## Technical Data Sheet

### 90-73212 Front Door Latch Upgrade

*Heritage I 8021, Tribute 8040*

**Date:** January 31, 2008

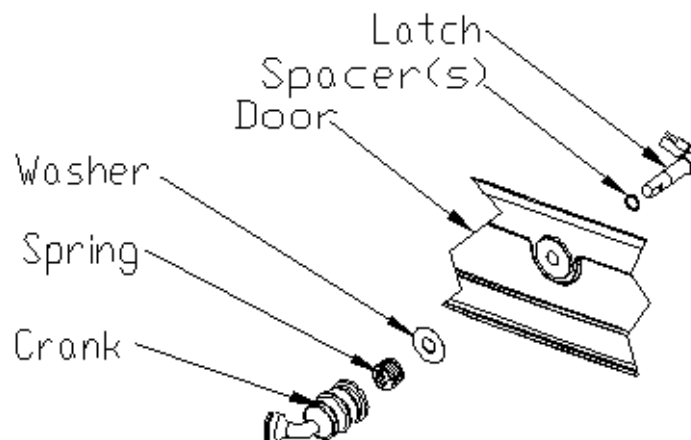
- 1) Remove and discard the old door latch assembly by loosening the setscrew with the allen wrench.
- 2) Install the new latch assembly as shown below. Start out with two brass spacer washers on the inside of the door. Thread the outer chrome crank (with the coil and large washer placed on the latch shaft as shown) onto the latch. Turn the crank until there is approximately 1/8" between the crank and the door.
- 3) Align the setscrew hole in the crank with the groove in the latch shaft and insert and tighten the set screw (the half dog tab will fit into the groove on the latch).
- 4) Check door seals using the "dollar bill test." Close the door on a dollar bill. If the bill pulls out without any resistance, then your stove's door is not sealing properly. Add or remove spacers to adjust gasket pressure.
